FINAL
MONITORING REPORT (MY1)

WARREN WILSON COLLEGE STREAM MITIGATION SITE
Buncombe County, North Carolina

NCDMS Project ID No. 100019
Full Delivery Contract No. 7188
USACE Action ID No. SAW-2017-01557
NCDWR No. 20171158
RFP No. 16-006991 (Issued: 9/16/16)

NCDMS Comment Responses:

Figures 2 & 2A-2E. Current Conditions Plan View
Tables 5A-5G. Visual Stream Morphology Stability Assessment
Table 6. Vegetation Condition Assessment
Vegetation Plot Photographs

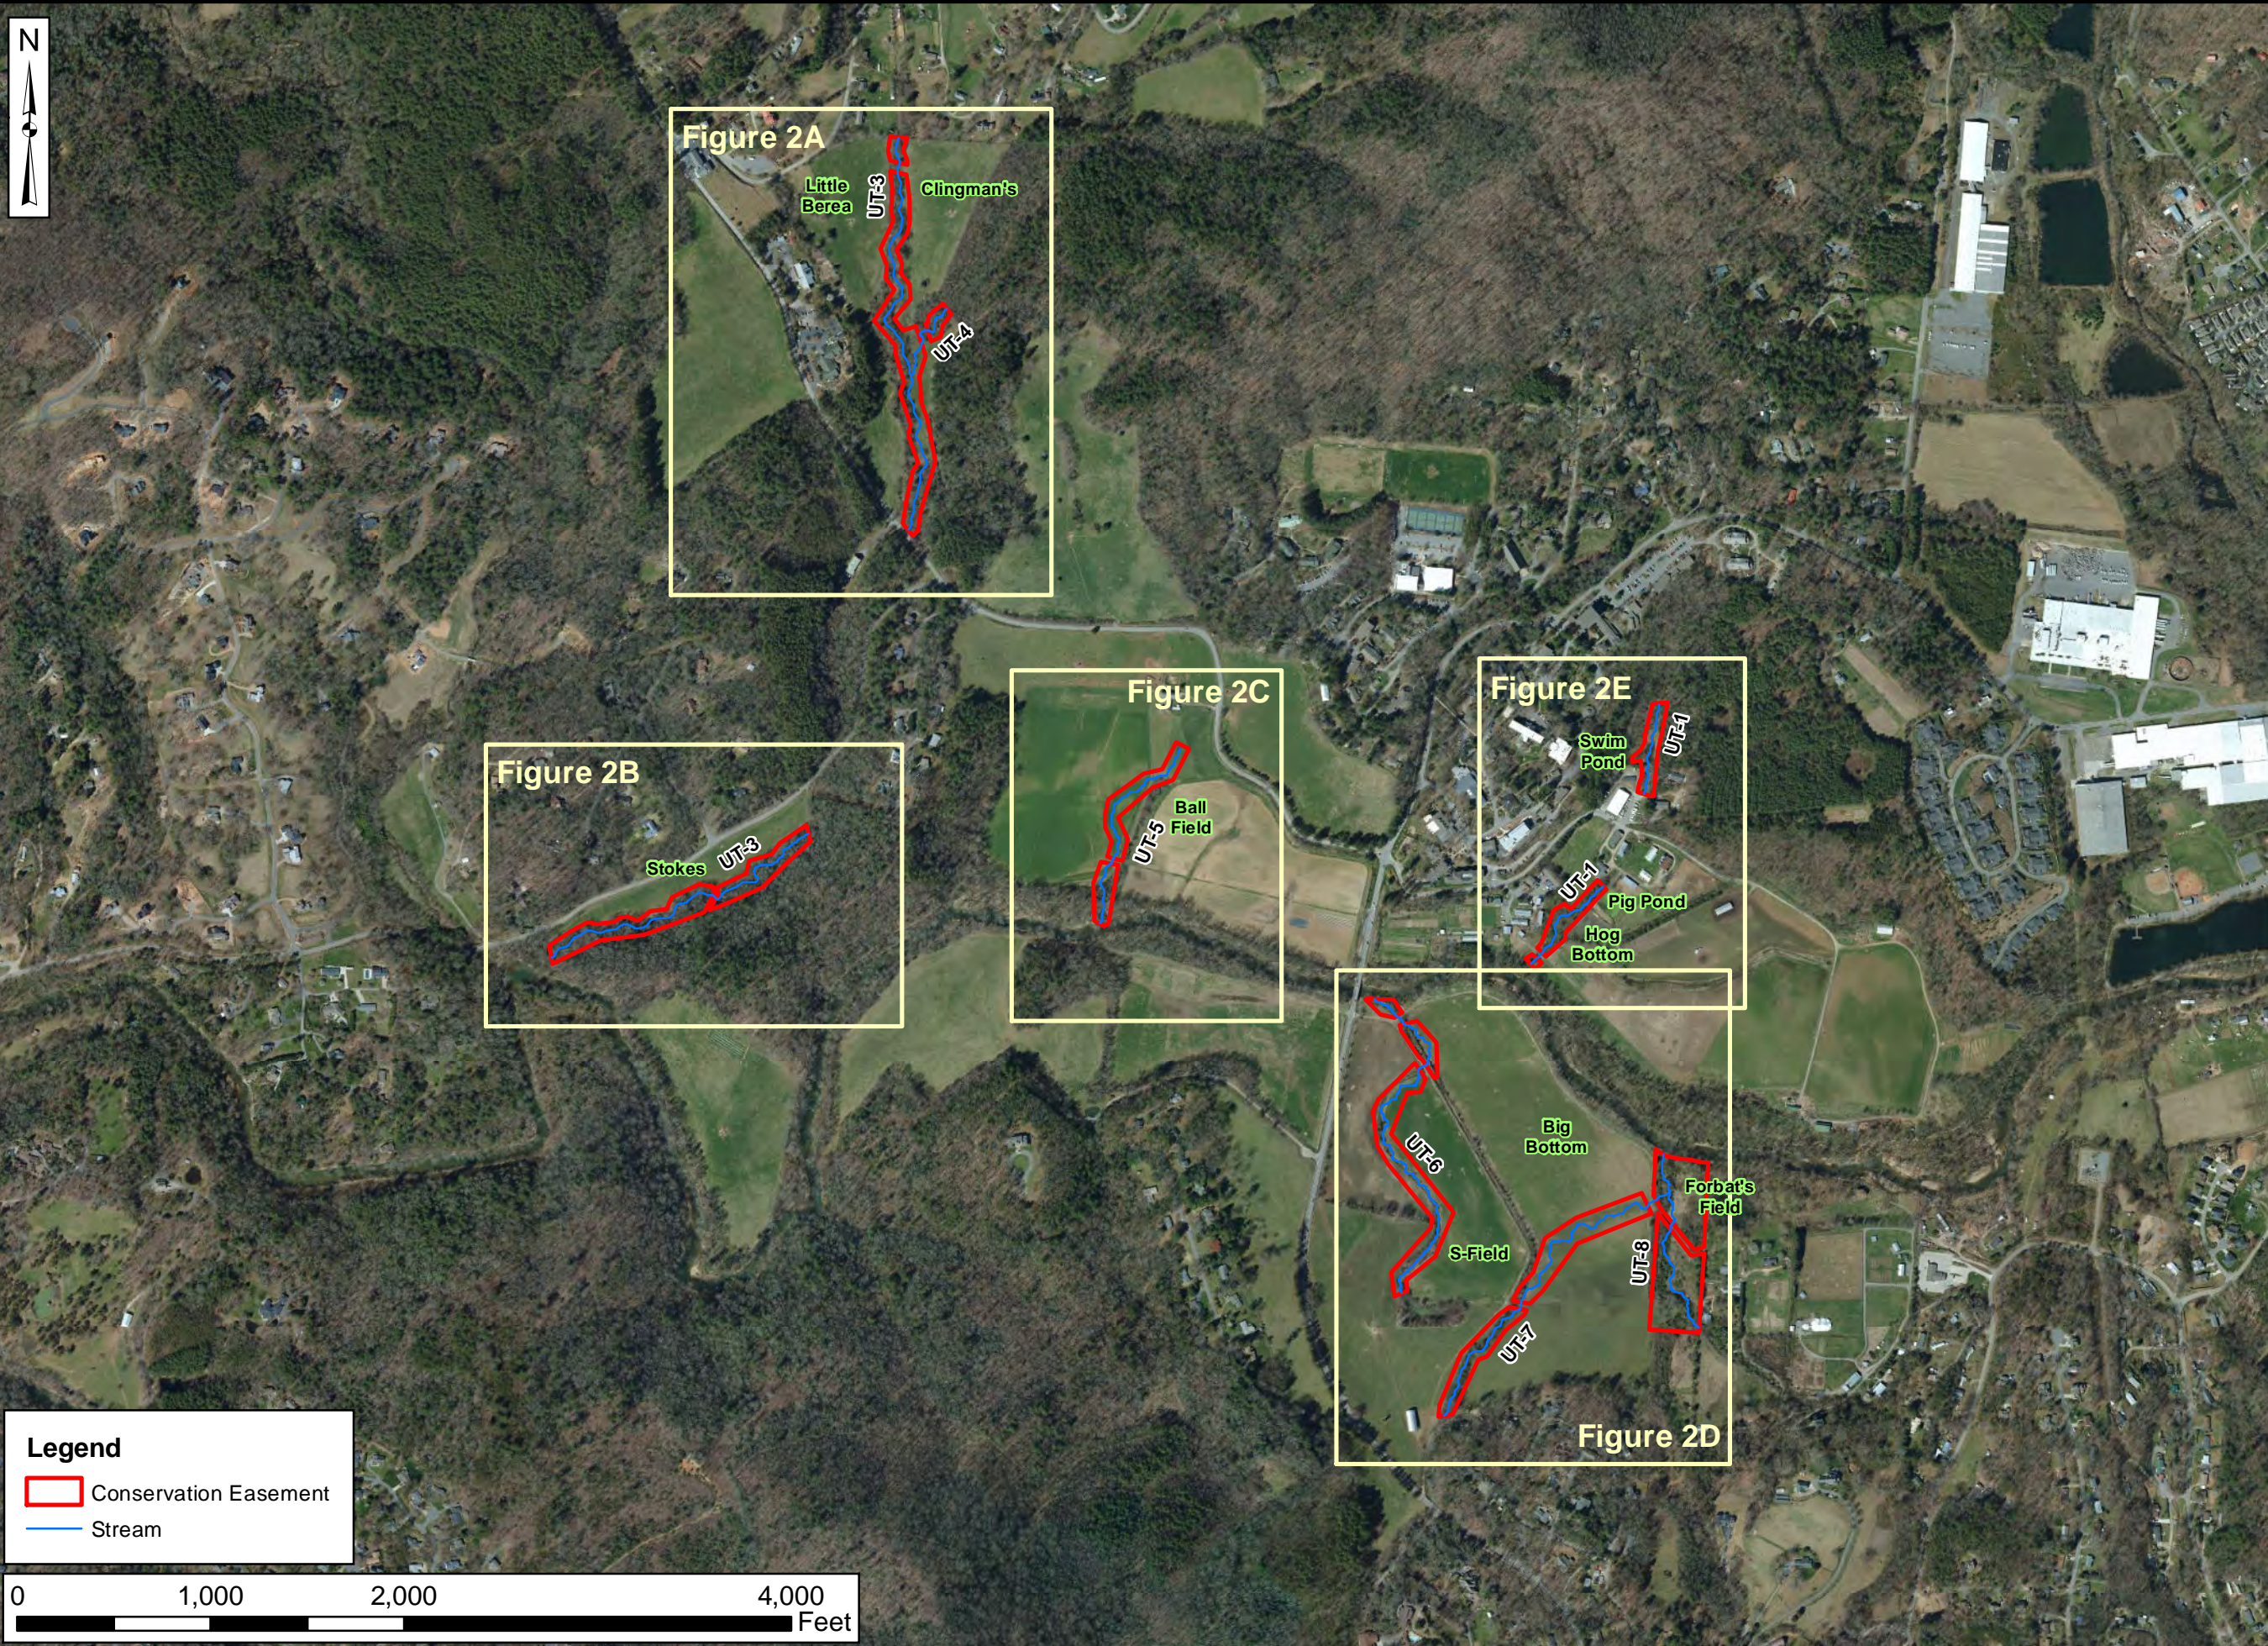
- **CCPV Map (Figure 2) & Table 6:** No invasive areas are shown on the CCPV map or reported in Table 6. Please confirm that current invasives on the site are beneath the mapping threshold (1,000 SqF) or revise the CCPV map and table as necessary.
Invasive species occurrences are scattered and are all currently below the mapping threshold. With the 2020 invasive treatments, it is not expected that invasives will be an issue, but if they increase in area to a point at or above mapping threshold during MY2 (2021), they will be reported in the annual monitoring report.

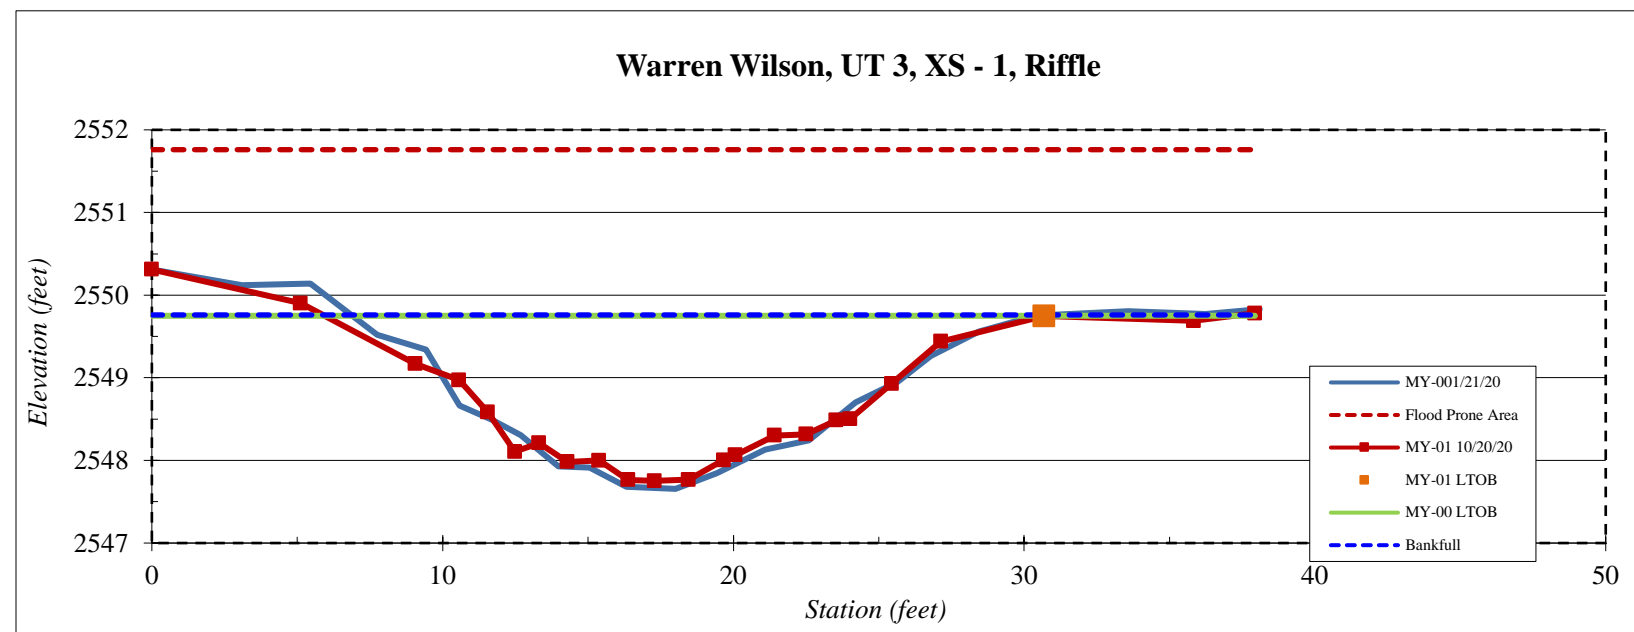
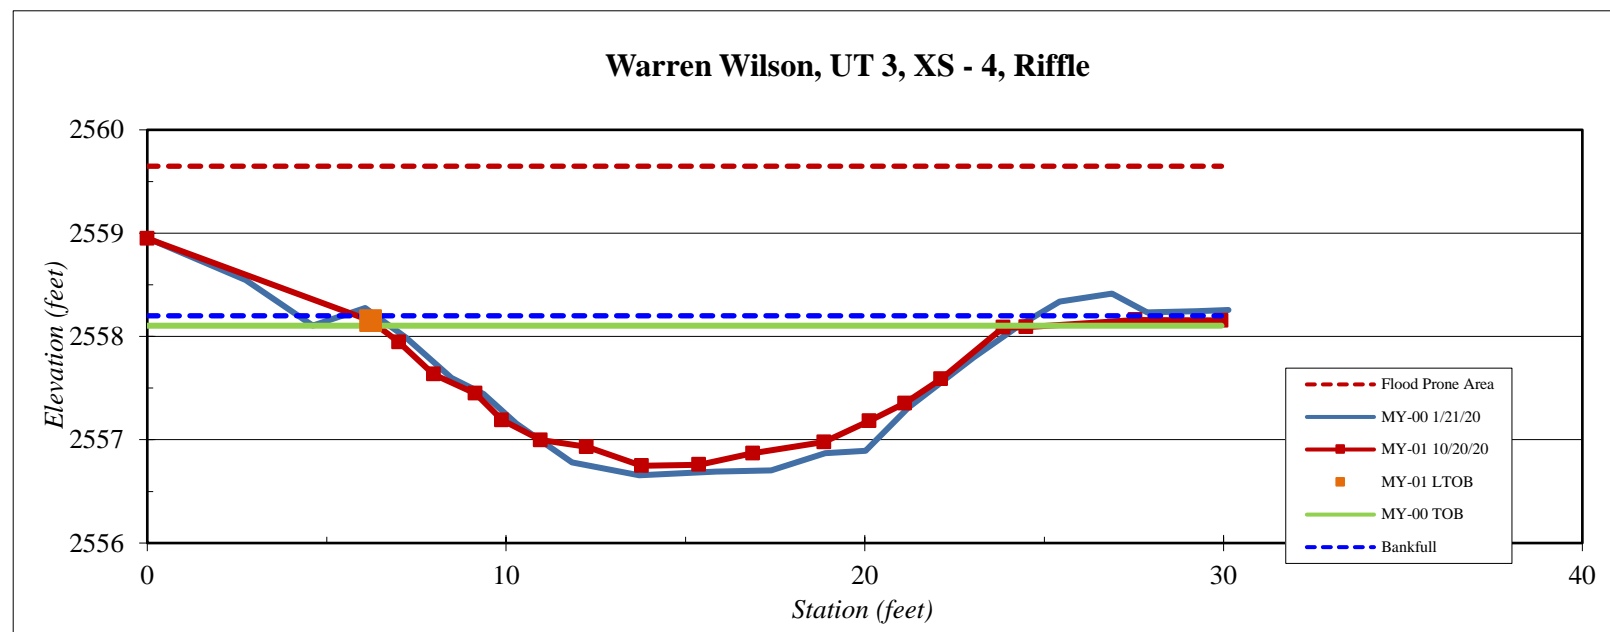
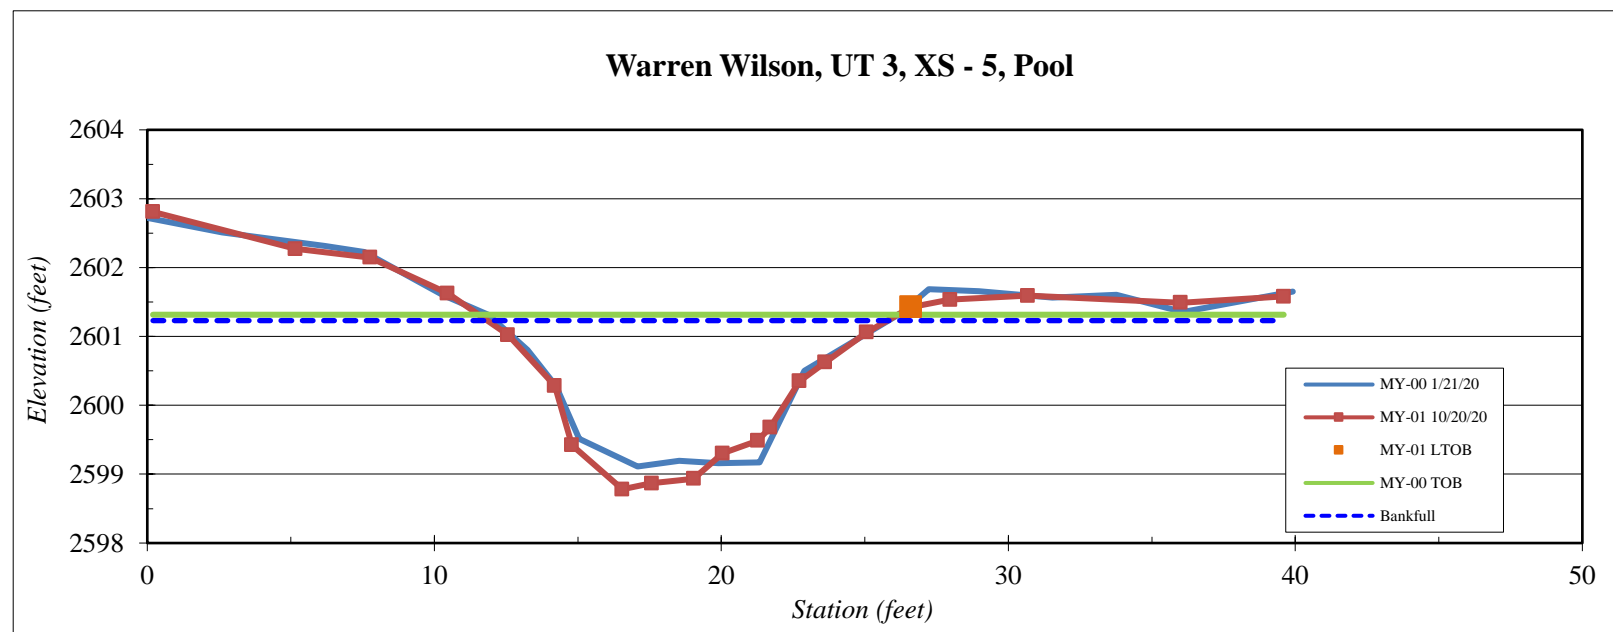
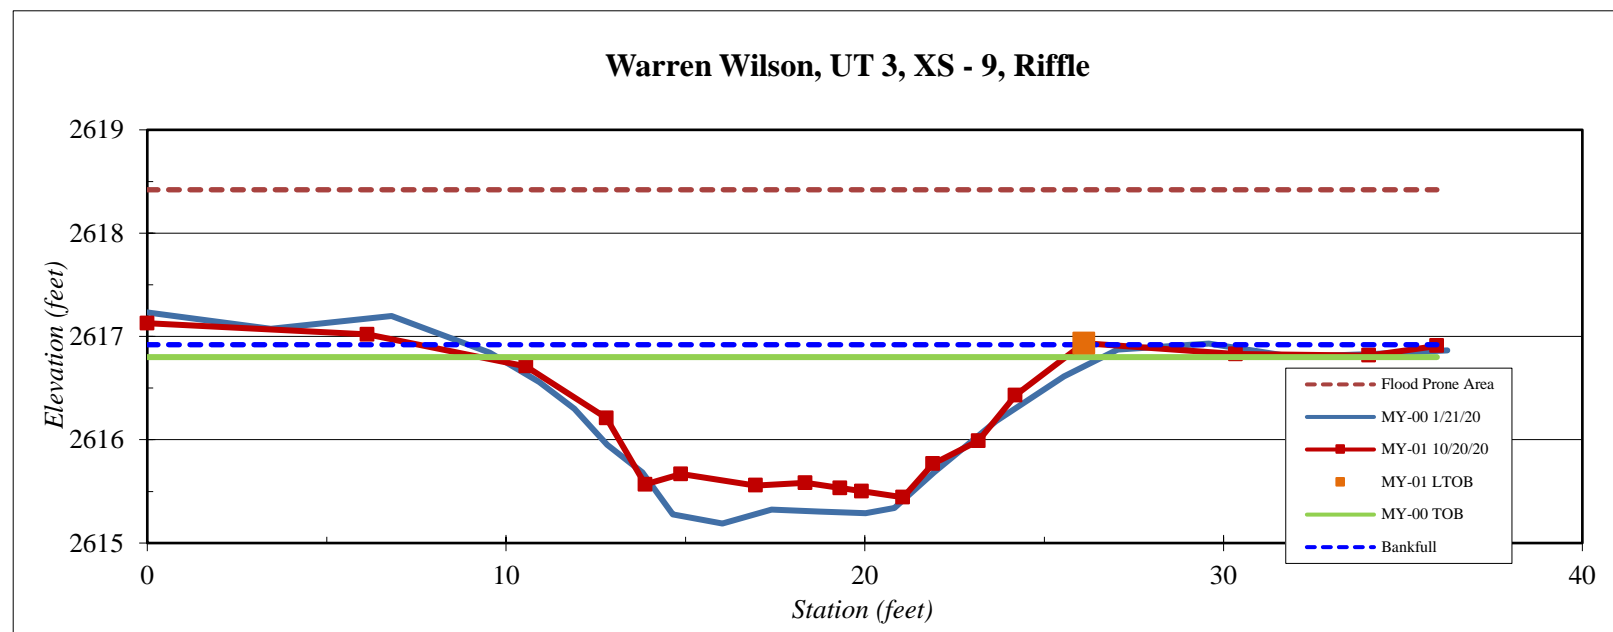
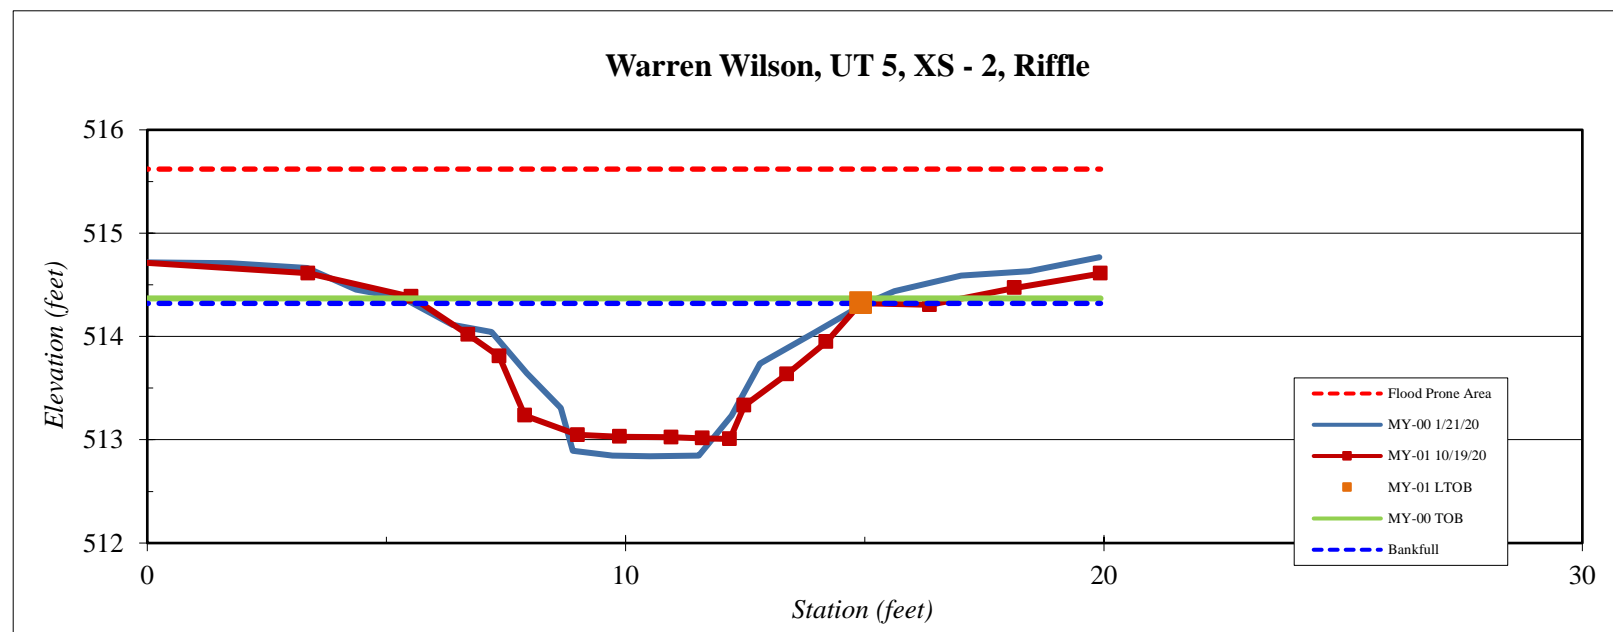
- **Appendix D – Cross Sections:** The bankfull line appears to be missing on some of the cross-sections provided. Please review and update as necessary.
When the bankfull elevations (dashed blue lines) were close to or equal to the MY-00 TOB (solid green lines), they were covered and were not visible. The bankfull lines have been brought to the front of the display order on the cross-section figures, so both lines are now visible when the elevations are the same.

Figure E-1. Year 1 (2020) Soil Temperature Data

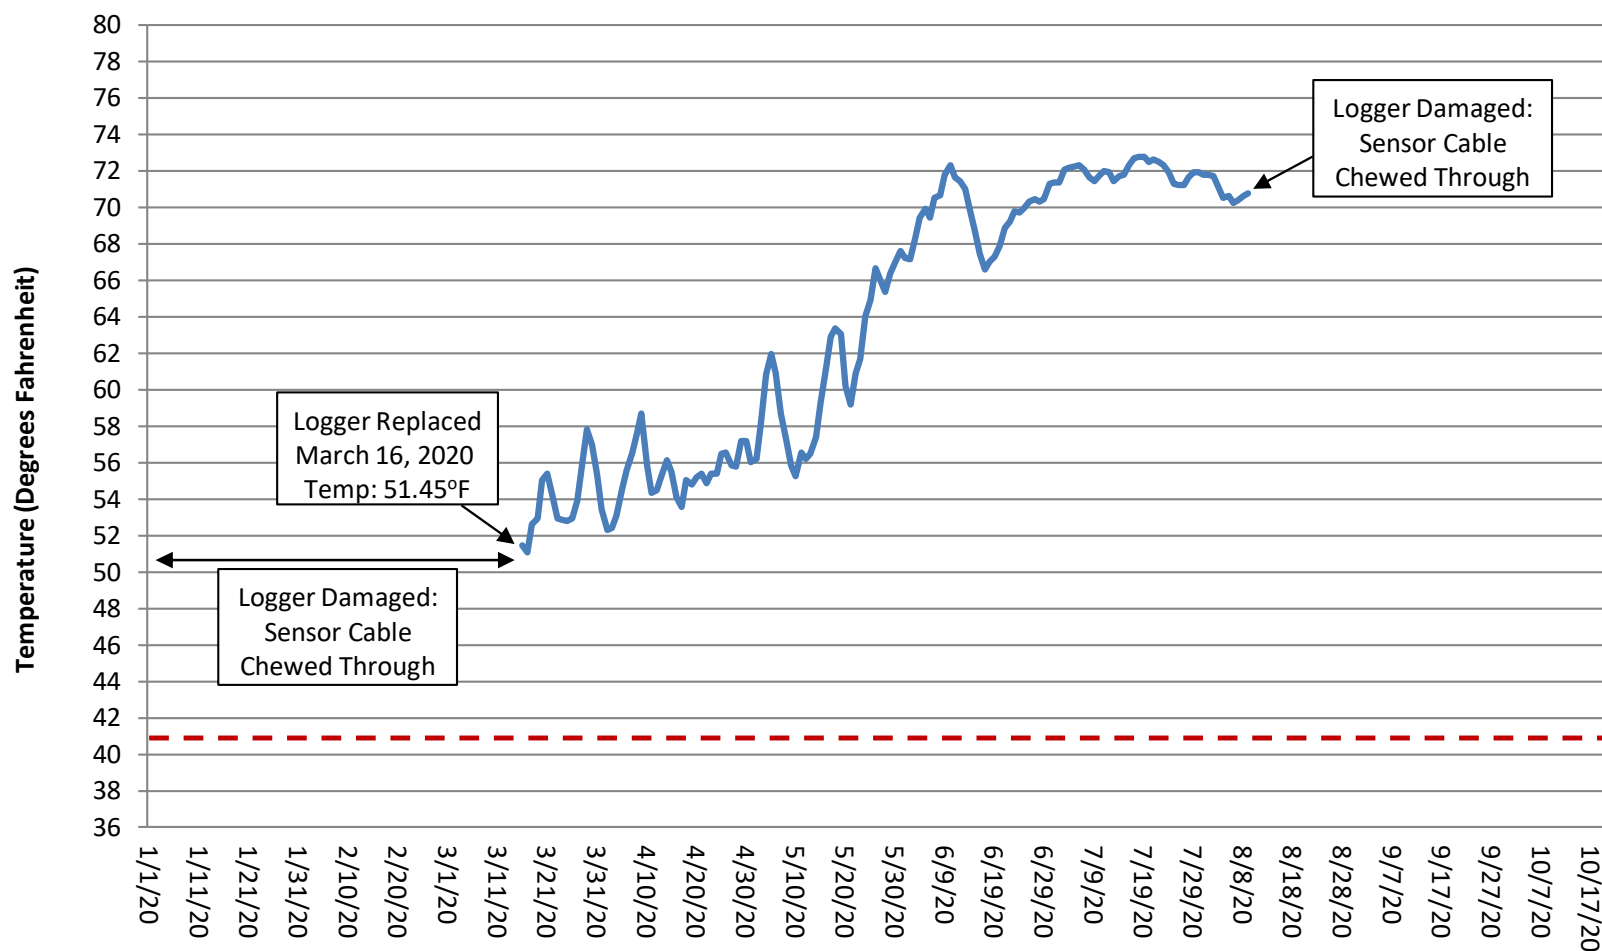
- **Section 2.1 Monitoring/ Wetland Summary:** Please include soil temperature data and bud burst documentation (photos) in the report appendices to substantiate the growing season start date of March 16, 2020. The location of the data should be referenced in the report text.

Bud burst photos and the soil temperature graph (Figure E-1) were added to Appendix E and are referenced in the footnote of the "Summary of Monitoring Period/Hydrology Success Criteria by Year" table in section 2.1.
